CITY OF PORTLAND

PERMIT

Permit Number: 090400

This is to certify that J J & K MANAGEMENT LLC John Mur
has permission to Install 4/12 Truss Roof on Existing Structure 6ft. Ice Water Shed-Bottom Edge, 3ft. Up the Side.
AT 1269 WASHINGTON AVE CE 402 C001001

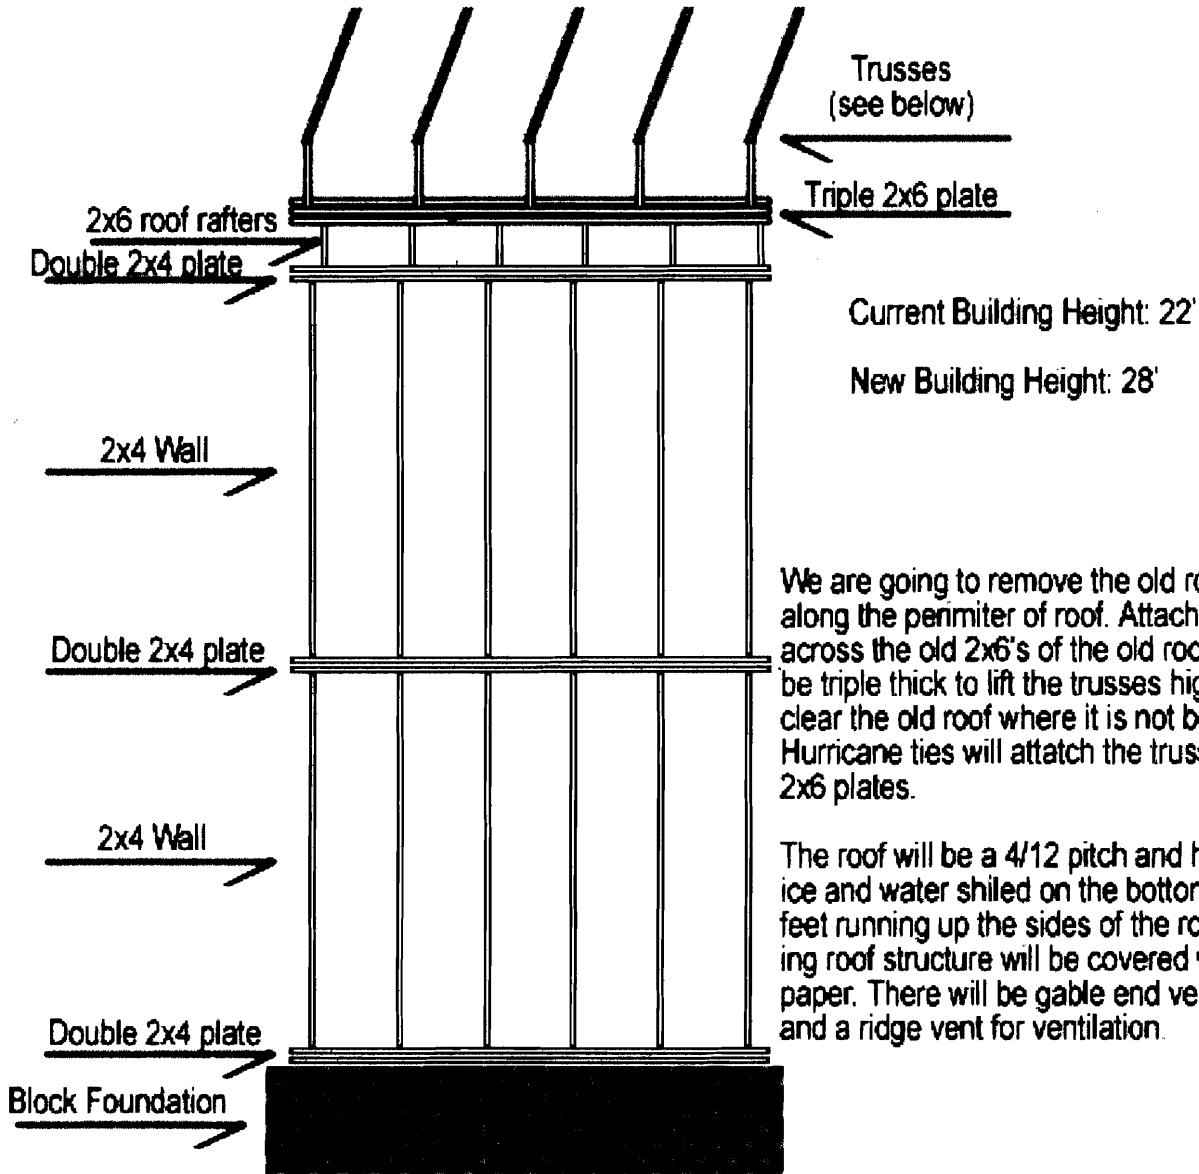
> John -
>
> You may be able to do it. First of all you need to provide a reason
> for changing the roof line.
>
> Second we would need a plot plan of the property either to scale or
> showing all the setbacks.
>
> The lot is legally nonconforming as to land arear per dwelling unit.
> I assume that it is also nonconforming as to setbacks, but that is why
> we need the plot plan.
>
> Since the building is nonconforming, you are not supposed to alter the
> shell of the structure, but we have allowed a flat roof to be modified
> to a pitched roof. The most we would allow would be a 4/12 pitch.
> You would have to submit a cross section showing the original pitch
> and a cross section showing the proposed pitch. Then we would have to
> review it before we made a final determination.
>
> Call me at 874-8709 if you have any questions.
>
> Ann Machado
> Zoning Specialist
>
> >>> John Murphy <john@tresmaine.com> 04/10 12:00 PM >>>

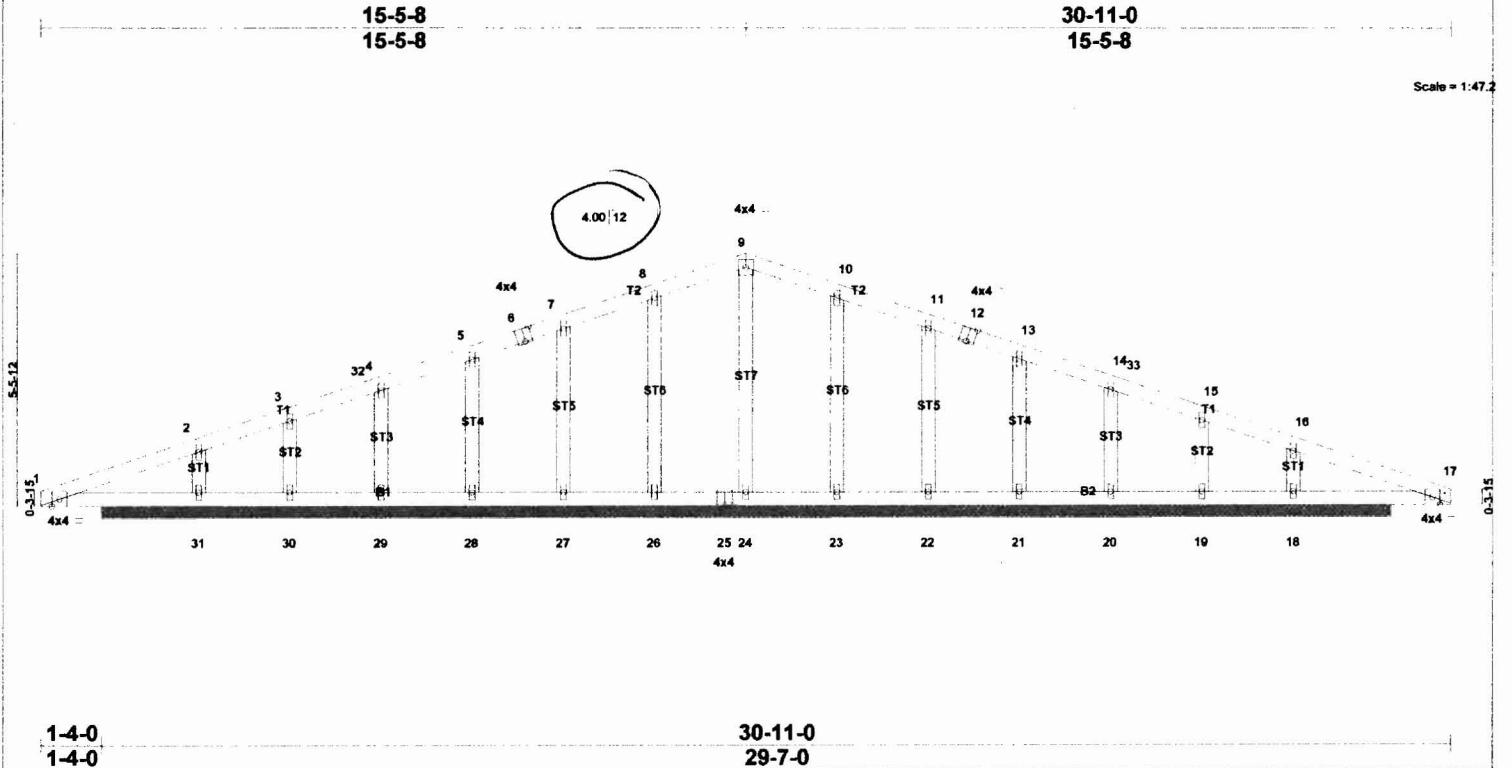
Submit an amendment to the original application to change the roof. It can be no higher than a 4/12 pitch. Make sure that you supply all the building information that Chris Hanson will require to review it.

has bbe
4/12

We are going to remove the old roof and decking along the perimeter of roof. Attach 2x6 plates flat across the old 2x6's of the old roof. The 2x6's will be triple thick to lift the trusses high enough to clear the old roof where it is not being removed. Hurricane ties will attach the trusses to the new 2x6 plates.

The roof will be a 4/12 pitch and have 6 feet of ice and water shielded on the bottom edge and 3 feet running up the sides of the roof. The remaining roof structure will be covered with asphalt felt paper. There will be gable end vents, soffit vents, and a ridge vent for ventilation.
